Access Compliance Report

Public Rights-of-Way

(Curb Ramps)

Intersection ID: 31747	Main Street: LEAF_PLUM_DR	Cross Street: WASHOE_PINE_LN	Location: NE
ADA ID: F5DD0C876EE7	Ramp Type: PerpDiag	Initial Pass/Fail: Fail	Overall Compliance: No
			Severity Score: 21.25

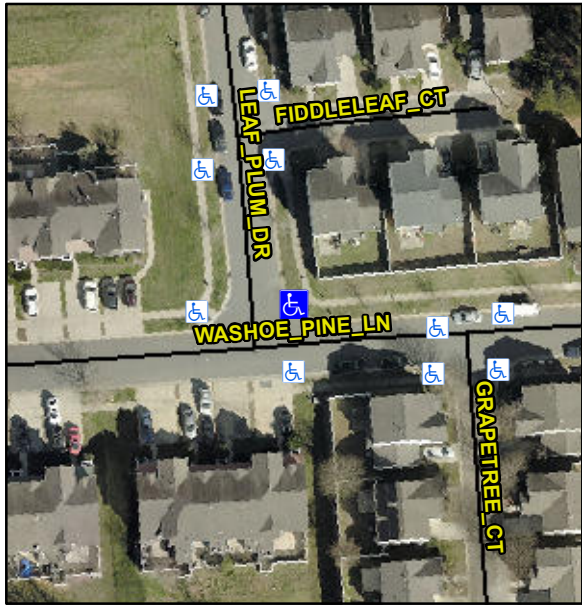
Codes/Mitigation Info/Possible Solution			Field Measurements/Component Compliance					
	Possible Solutions:		Compliance	Description	Data	Compliance	Description	Data
	Remove & Replace Curb Ramp With Two New Directional Ramps or Equivalent.		N/A	Ramp Length (in)	89.0	No	Ramp Slope (%)	9.0
			No	Ramp Width (in)	45.5	Yes	Ramp XSlope (%)	1.8
			N/A	Flare Type LT	N/A	N/A	Flare Type RT	N/A
			N/A	Flare Slope LT (%)	N/A	N/A	Flare Slope RT (%)	N/A
			N/A	Flare Traversable LT?	N/A	N/A	Flare Traversable RT?	N/A
			N/A	Landing Length (in)	N/A	N/A	DWS Provided?	N/A
			N/A	Landing Width (in)	N/A	N/A	DWS Contrast?	N/A
			N/A	Landing Slope (%)	N/A	N/A	DWS Length (in)	N/A
			N/A	Landing X Slope (%)	N/A	N/A	DWS Full Width?	N/A
Street 1 NameLEAF PLUM DR Stop Condition-Street 2StopSign Street 2 NameWASHOE PINE LN Stop Condition-Street 1None	Surveyor Notes: N/A		N/A	Landing Curb? (Y/N)	N/A	N/A	DWS Offset (in)	N/A
	PROW/ADA: Not Found, R304.5.1, R304.2.2		N/A	Shared Landing?	N/A

N/A	Gutter Ponding?	N/A	N/A	Gutter Slope (%)	N/A
			N/A	Gutter Lip Ht (in)	N/A	N/A	Gutter X Slope (%)	N/A
			N/A	Painted X Walk1?	No	N/A	Painted X Walk2?	No
				X Walk 1 Direction	To W		X Walk 2 Direction	To S
			N/A	X Walk 1 Width (in)	N/A	N/A	X Walk 2 Width (in)	N/A
				X Walk 1 Slope (%)	7.7		X Walk 2 Slope (%)	0.3
				X Walk 1 X Slope (%)	0.8		X Walk 2 X Slope (%)	7.6
			N/A	Ramp inside XWalk1?	N/A	N/A	Ramp inside XWalk2?	N/A
			Road Slope (%)	3.1	N/A	Clear Space?	N/A	
			Road X Slope (%)	7.0	N/A	Clear Space to XWalk (in)	N/A	
		N/A	Any Obstructions?	N/A	N/A	Storm Grate/Utility Hazard?	N/A	
			Obstruction Type			Storm Grate/Utility Type		
					N/A			N/A
						Yes	Surface Condition? (G/P)	Good
Total Cost:		\$ 3200.00
